SERVICE BULLETIN No.1129

COACH MODEL	: T2145 and C2045
BULLETIN TYPE	: Product Improvement
MANUAL & SECTION	: Operator's Guide Book: Section 2 – Operating Instructions Spare Parts Manual: N/A
PARTS BOOK REVISION	: No
DATE	: April 29, 2005
SUBJECT	: ADA platform lift interlock – warning lamp lens
TERMS & CONDITIONS	: No claims will be accepted with reference to this Bulletin

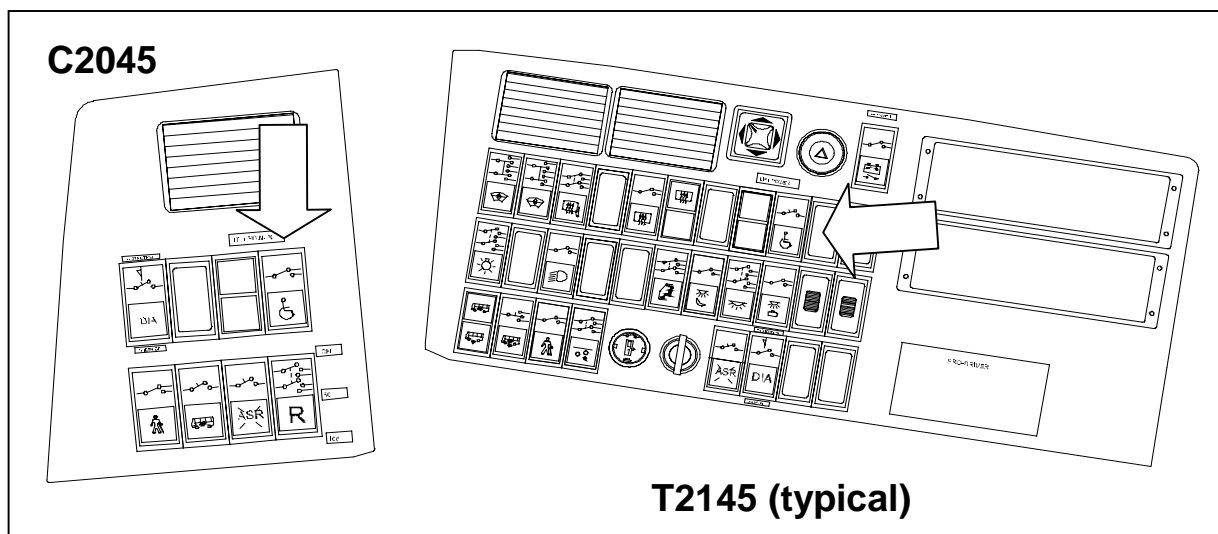
As from the above-mentioned coach models the interlock system has been changed. As one of the safety enhancements in addition to the already existing safety features installed on these vehicles, the color of the "lift power on" warning lamp on the dashboard has been changed to red.

- 1) Locate the ADA platform lift interlock warning lamp on the dashboard (see Figure 1).
